SUBJECT: Quail Ridge Addition Comments DATE: 7/27/84

Re: Quail Ridge Addition

PRELIMINARY PLAT
QUAIL RIDGE ADDITION
 CITY OF ROCKWALL
 ROCKWALL COUNTY, TEXAS

S.H. No. 205

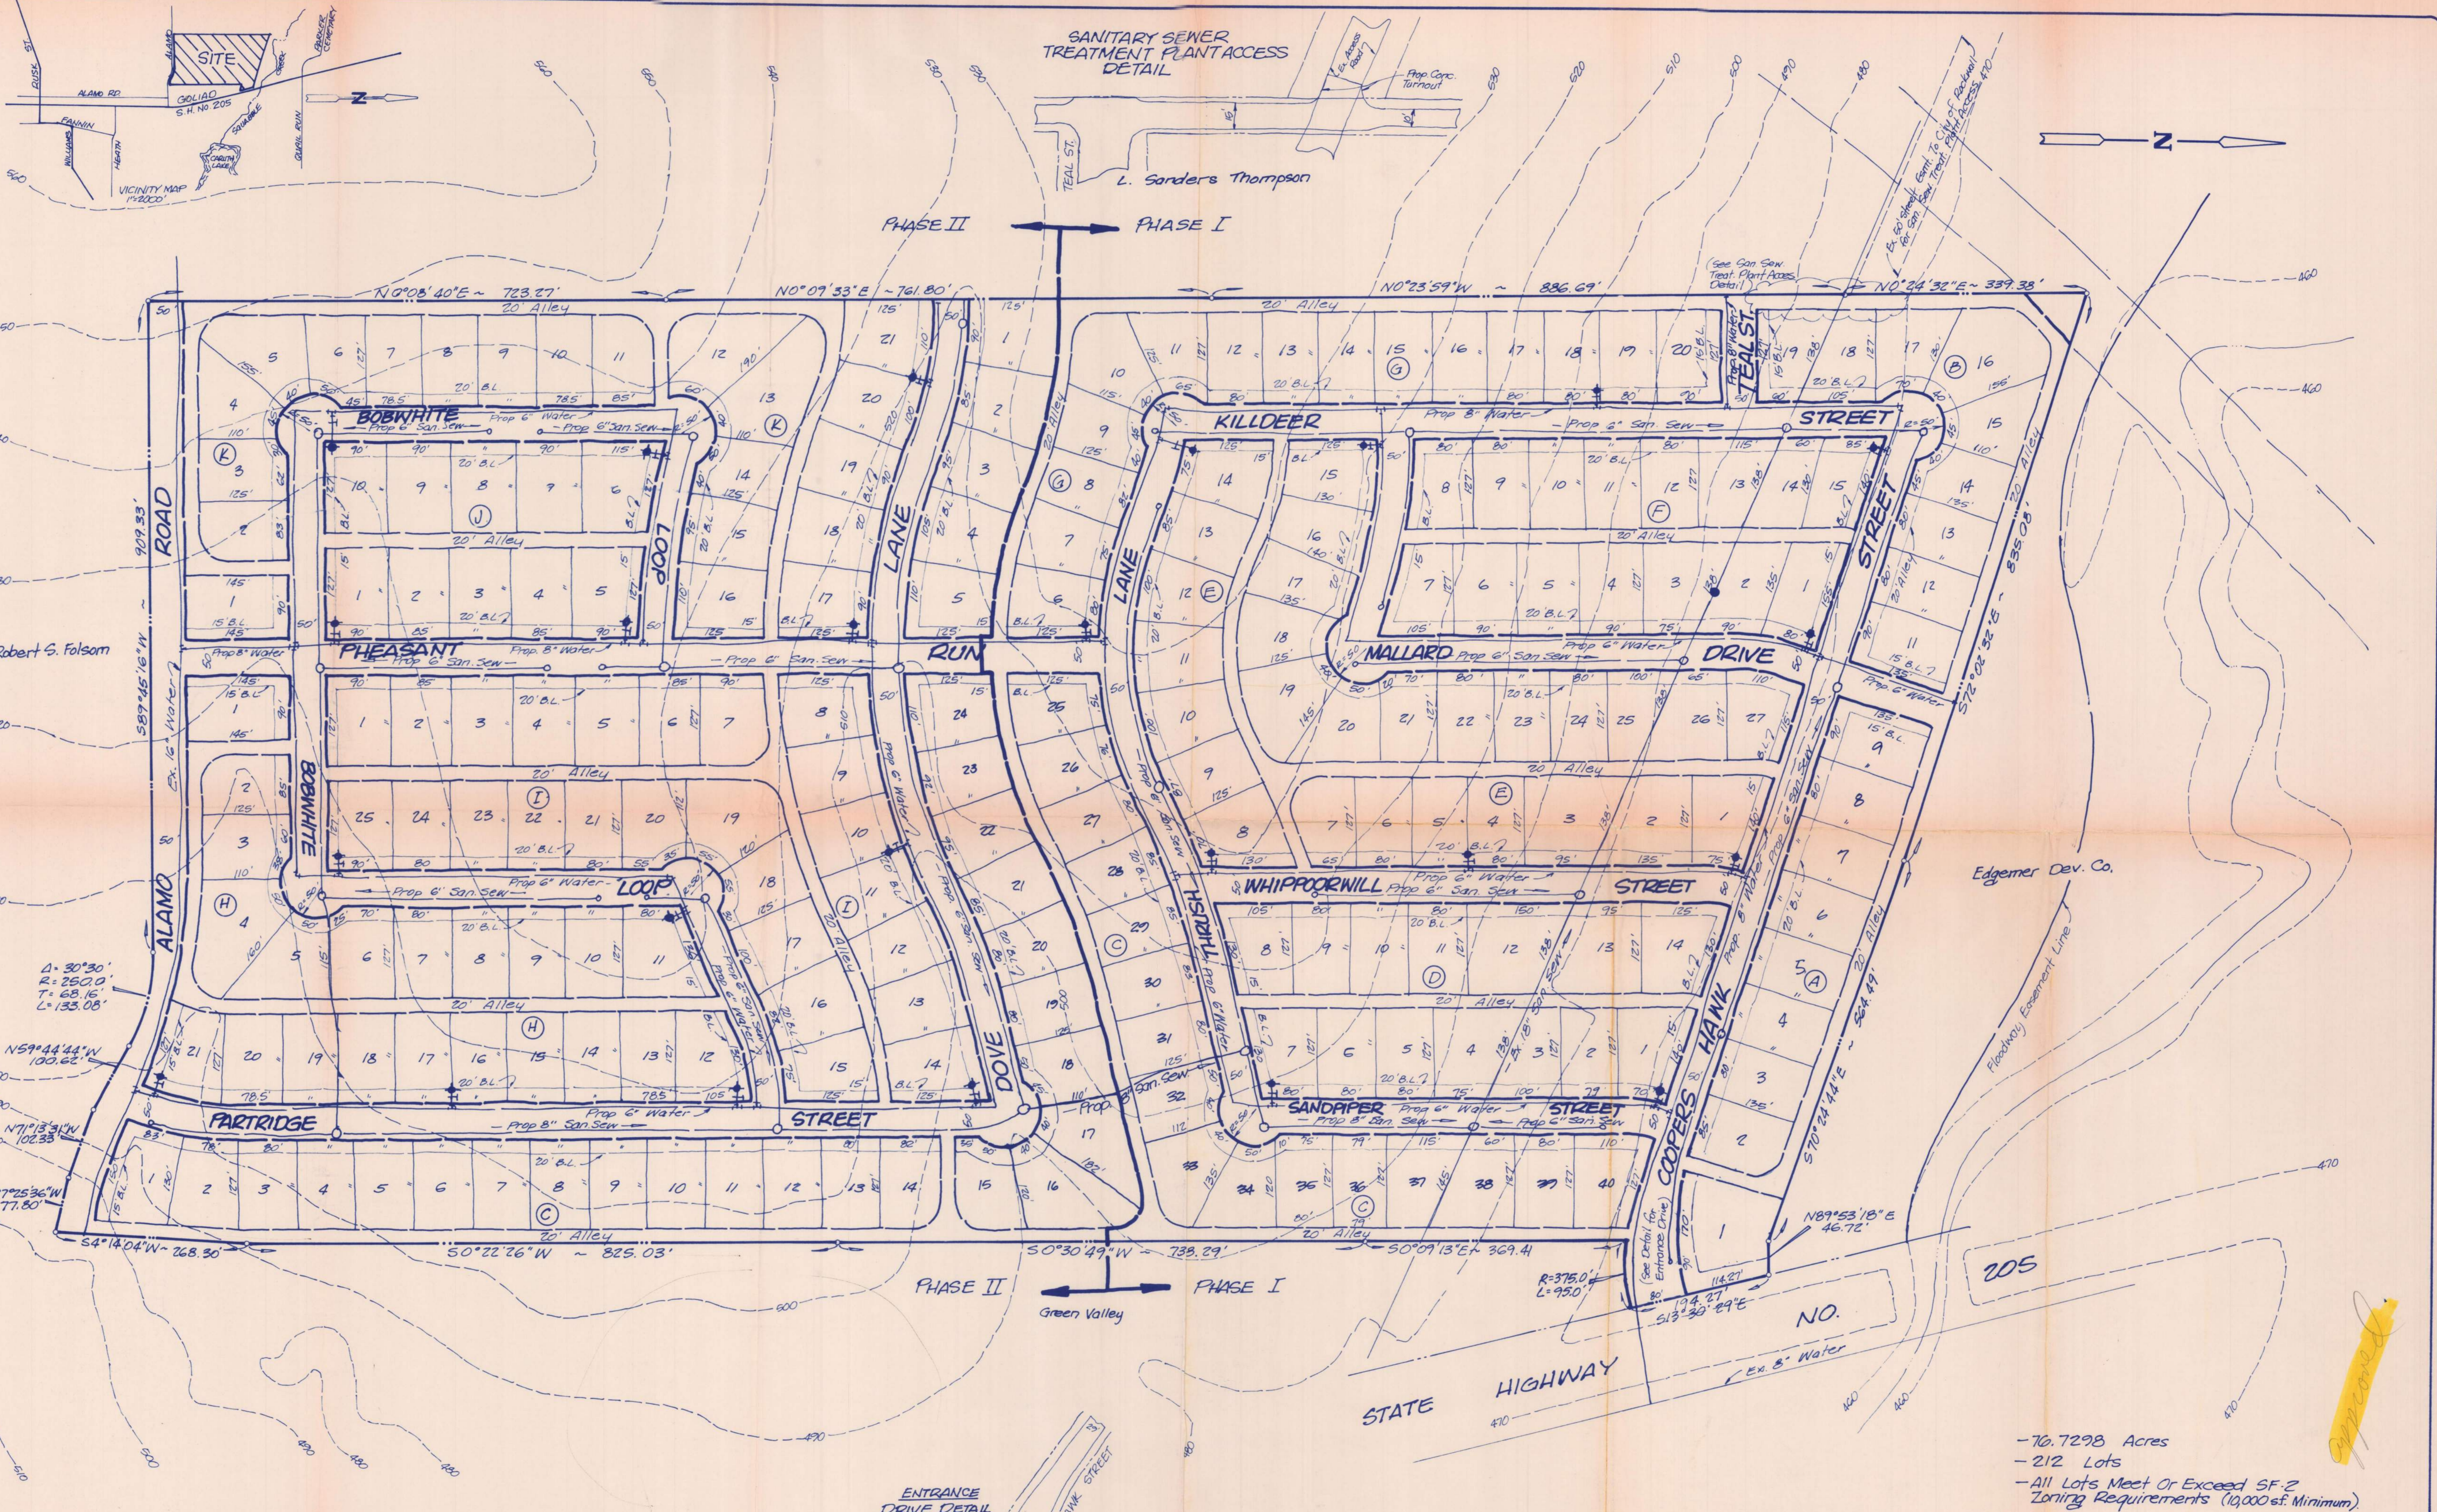
- 1. Area contains some land zoned Commercial which must be rezoned.
- 75 2. All lots must be 10,000 sq. ft.
- 3. City must have access to sewer plant.
- 4. 16" water line on Alamo must be activated.
- 5. Dove Lake stub unuseable - existing lots.
- 6. Alamo Road must be improved.
- 7. Access to SH-205 must meet City design standards, not too steep.
- 8. Flood plain study needed.
- 9. Route survey for proposed extension of Lakeshore Drive needed.
- 10. Quail Ridge Drive too similar to Quail Run Road; Mallard Drive, rename N-S Thrush Lane; Partridge Street, Bobwhite Loop.

On August 9, 1984, the Planning and Zoning Commission voted to table your preliminary plat until access to the sewer plant is resolved, the project is divided into two phases, and the entrance to SH-025 is designed and it is determined whether the two lots adjacent to the road are useable. All Staff comments provided earlier also apply. To appear before the Planning and Zoning Commission again on September 13th, please submit 8 copies of the revised plat by August 27th.

MESSAGE:
- On September 13, 1984, the P&Z approved your preliminary plat subject to:
1) all lots enlarged to minimum 10,000 sq. ft.
2) commercial areas rezoned to SF-10
3) final plat of Phase 2 subject to route study and improvements to Alamo Rd.
4) Lot 1, Block A incorporate park area with alley relocated and large side setback
5) Park area on south side of Coopers Hawk Street removed from plat

MESSAGE:
- On October 1, 1984, the City Council approved your preliminary plat subject to the Commercial area being rezoned to "SF-10" and the final plat of Phase 2 subject to a route study and improvements to Alamo Road. You still must bring all lots up to 10,000 sq. ft.
